U.S. Army Corps of Engineers
Alaska District

Final Proposed Plan Building A-711 HTRW Kodiak Navy/Army Formerly Used Defense Site

Kodiak, Alaska
FUDS Project No. F10AK1007-04

July 2023

**Figure
1**

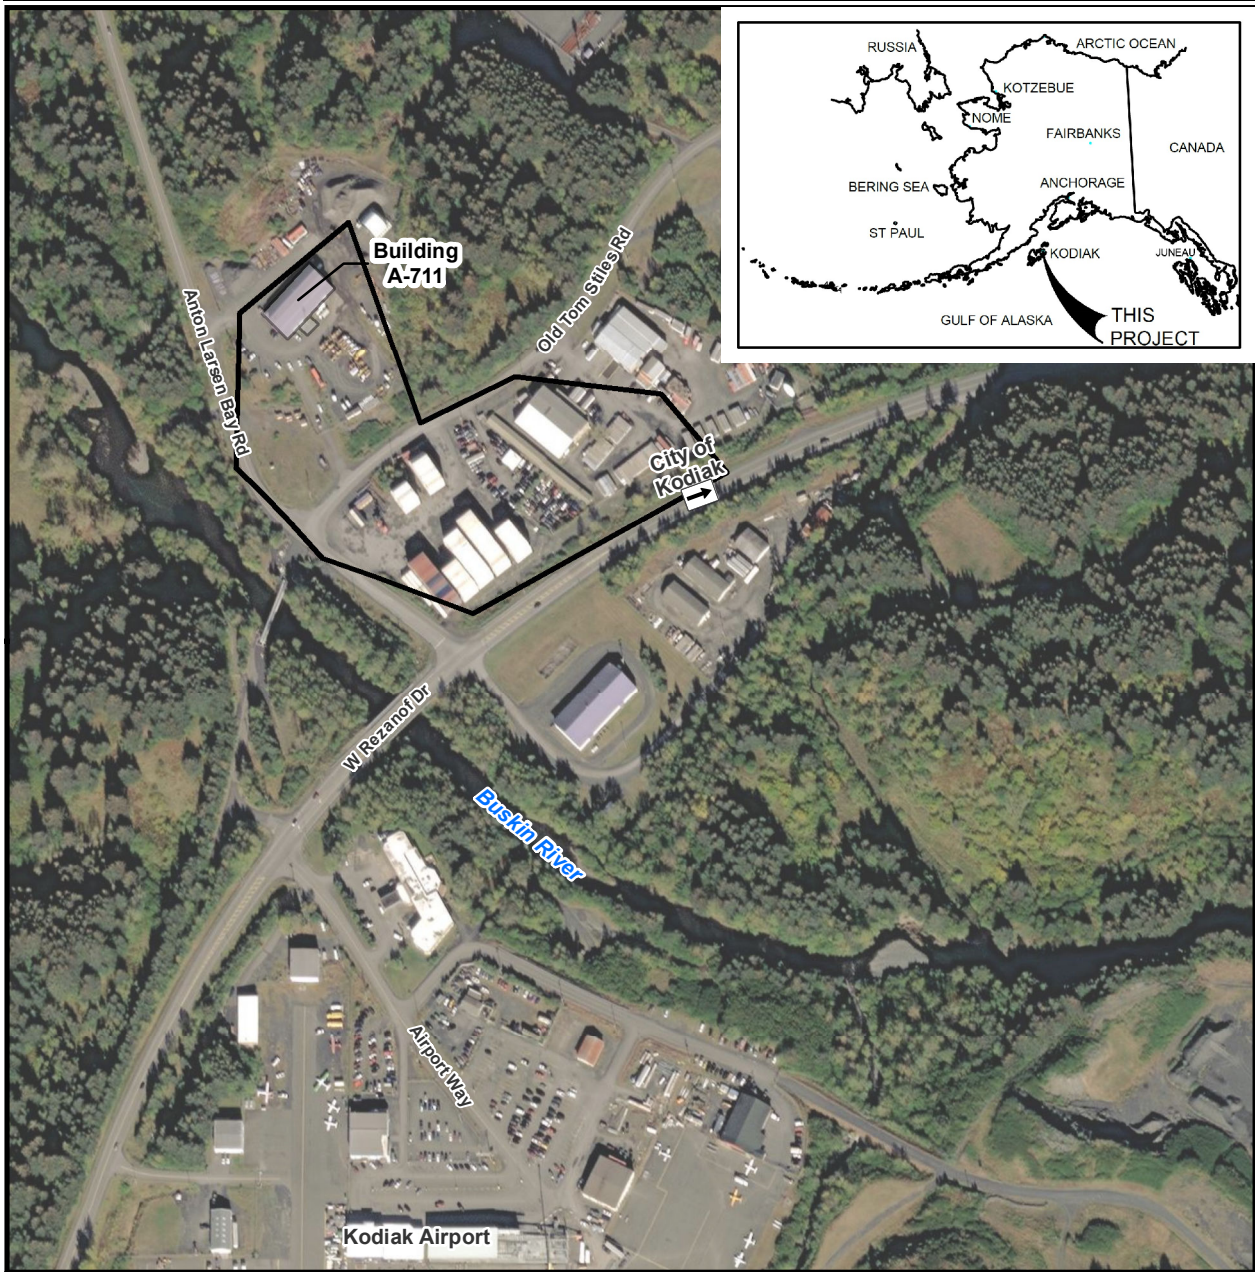
8.		Figures	<p>Figures 1 and 2: Please see and apply related comments above, particularly comment pertaining to miscellaneous boundaries associated with the site and make revisions and amendments to these and other figures and related narrative sections accordingly.</p> <p>Figure 2: This figure is titled ‘main site features’ however only focuses on ‘parcel boundaries’. This figure title should be revised to e.g. ‘USCG Property Parcels Within A-711 Project Area’. The Buskin River should be labeled on all figures.</p> <p>A new figure should be included that actually identifies all of the relevant ‘main site features’ including both terrain (e.g. river and flow direction, roads, buildings, utilities) and constructed, and also depict the known extents of soil and groundwater contamination including those that are currently inferred as well as those for which USACE-FUDS is not the lead RP (e.g. the DOT Building, APL, etc.).</p> <p>General: The USCG recently completed its Buskin Waterline project and the current day site features and ground surface may differ from what is depicted in the imagery being used for the figures in this document. Are there newer aerial images that would provide a more current representation of the site? Please specify the date of the imagery in the figures.</p>	<p>Revised all figures to show property and project boundaries.</p> <p>Figure 2 title has been revised to: USCG Property Parcels within A-711 Project Area and Main Site Features. Buskin River has been labeled on all figures.</p> <p>The 2019 NAPL confirmed and inferred delineation was included on Figure 3.</p> <p>An aerial image from 2020 was used in the updated Figure 3; it is noted on the Figure</p> <p>Added all investigation points to Figure 3 and noted that the previous investigations and remedial actions limited to CERCLA investigations and/or CERCLA COC actions only; other non-FUDS investigations and actions are not depicted. The extend of NAPL from 2019 is depicted on Figure 3.</p>

6	Site Background and Characteristics	“The building remains under lease...” Suggest clarifying that this is Building A-711.		Clarified the leased building is A-711.	A		
7	Figure 1	Suggest adding the outline of the former Quartermaster Gas Station to the figure.		An outline of the former Quartermaster Gas Station has been added to Figure 2.	A		
8	Prior Investigations	“Any investigations focusing on POL impacts only are not discussed...” Suggest revising the sentence as follows:” In addition to the list below, there have been multiple investigations at the site focusing on		Revised sentence as suggested to: In addition to the list below, there have been multiple investigations at the site focusing on POL impacts. Those investigations are not listed here because a separate project has been created	A

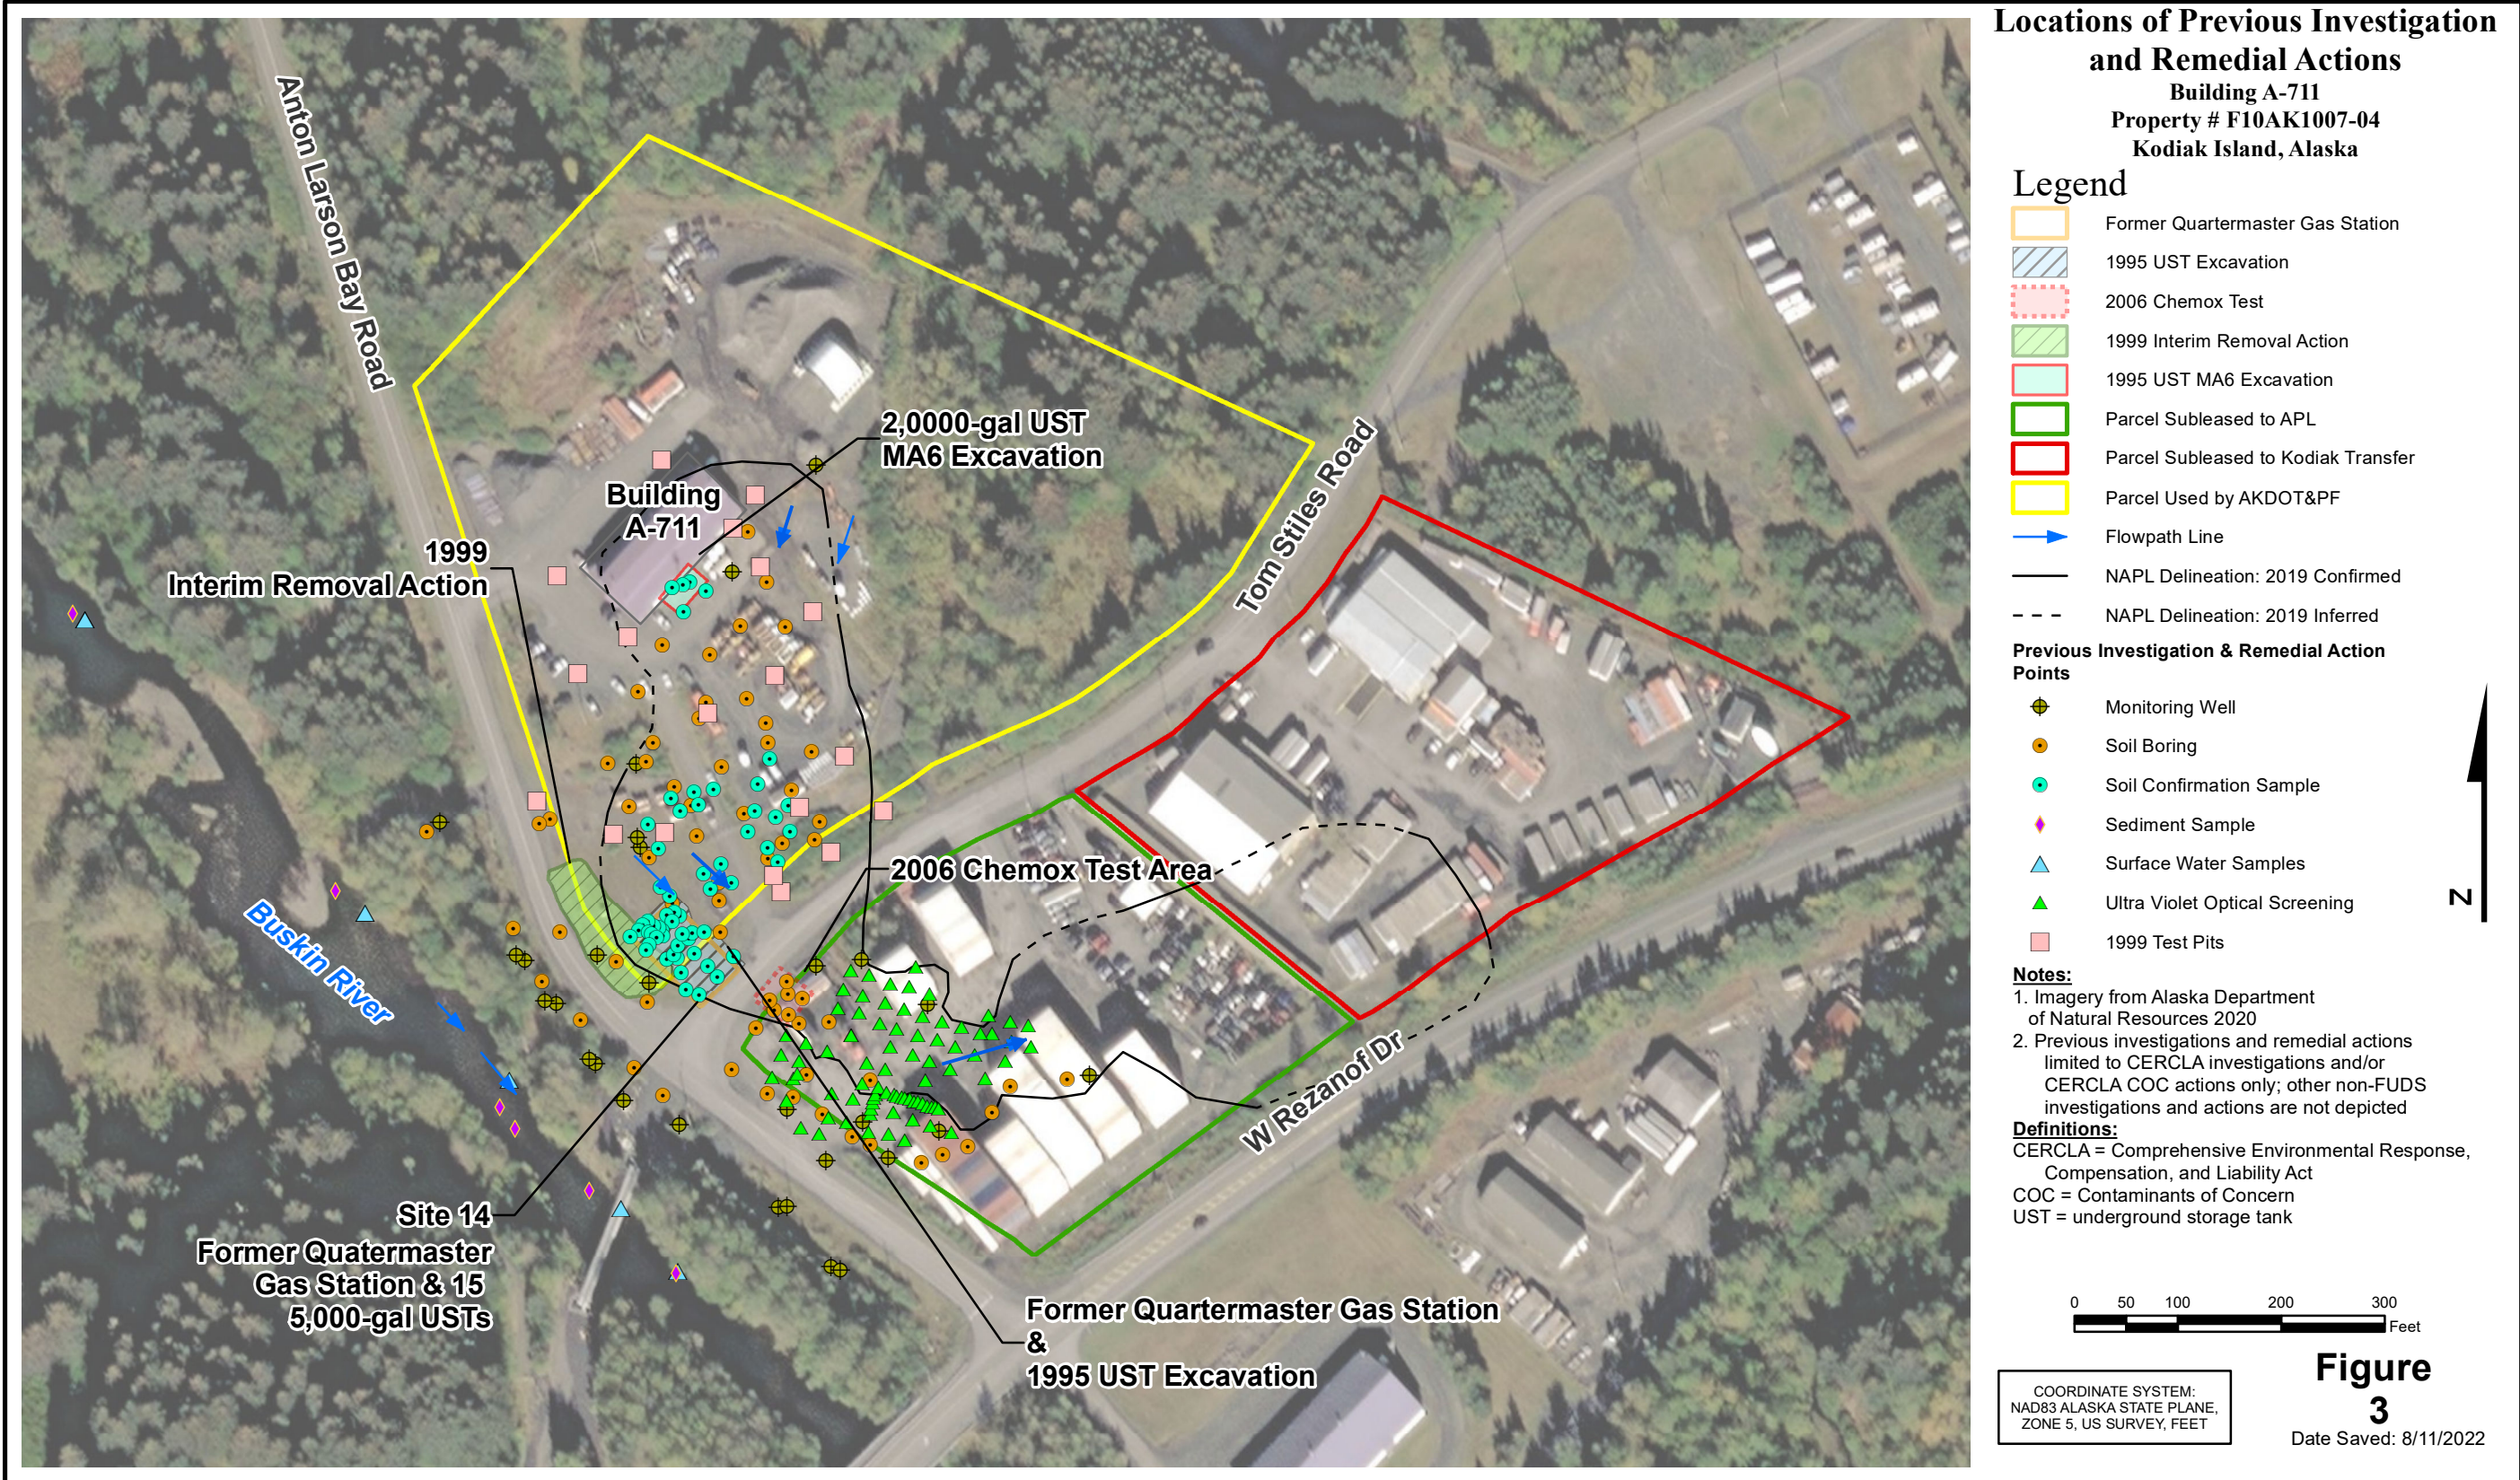
<p>Figure 3: ADEC's understanding is that more investigation points were conducted in the southern/southeastern portions of the site that are not depicted in this figure.</p> <p>Title should be amended and a figure note included to clarify whether these are limited to CERCLA investigations and/or CERCLA COC actions only, and that there are other 'non-FUDS' investigations and actions that are not depicted.</p> <p>The known and inferred extents of contamination in groundwater and soil should be depicted on this figure along with the current existing land use control boundaries.</p>	
9.			End of ADEC Comments

This figure appears to identify the previous excavations, but not the previous investigation areas. Please clarify. A Table showing the potential CERCLA COCs that have been detected and their maximum concentrations and locations on a figure would be useful to show the extent of the contaminants identified in the past investigations.

2.	1	Site Bkgd.	Revisions are necessary to better clarify and present what is being referenced as ‘property’ and/or ‘project’ boundaries in narrative discussions and in figure depictions throughout the document. ADEC	Thank you for the comment. Figure 3 will be revised to show the NAPL boundary.

Figure 3 was revised to show all investigation and remedial action points. A table listing the CERCLA COCs has been created in the document (Table 1). None exceed EPA screening levels. These soil boring sample locations are not identified by ID on Figure 3 since none of the COCs exceeded screening levels.
